**SYSTEM CHECK, BRP ENGINES**

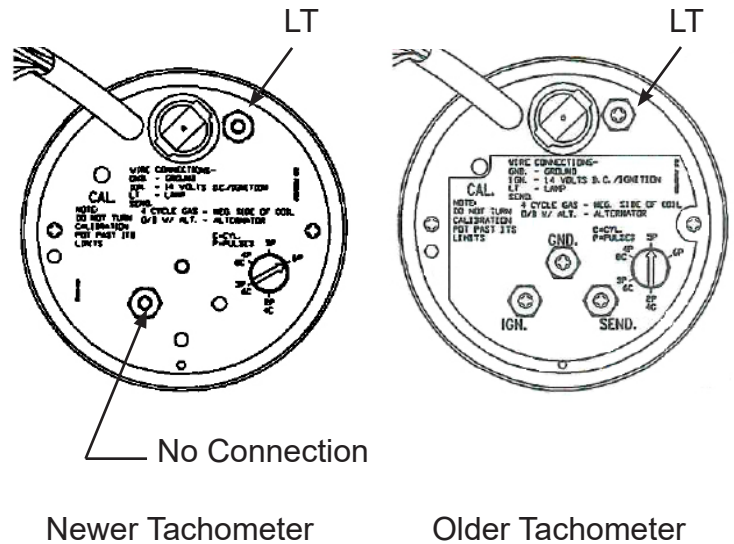
In late 2000, Teleflex engineering team re-designed the BRP System Check tachometer and removed the requirement to have separate power (IGN), ground (GND), and tachometer signal (SEND) from the back of the BRP System Check tachometer. The new BRP System Check tachometer receives all the information and power through the harness.

If you are replacing an older tachometer with a new one and have extra wires for power, ground, and tachometer signal, these connections are no longer necessary on the new tachometer. There is a stud on the back of the new tachometer in the same place as the old IGN (power) stud but no electrical connection should be made on this stud. The only connection which need to be made in addition to the plug is the power for the light (LT).
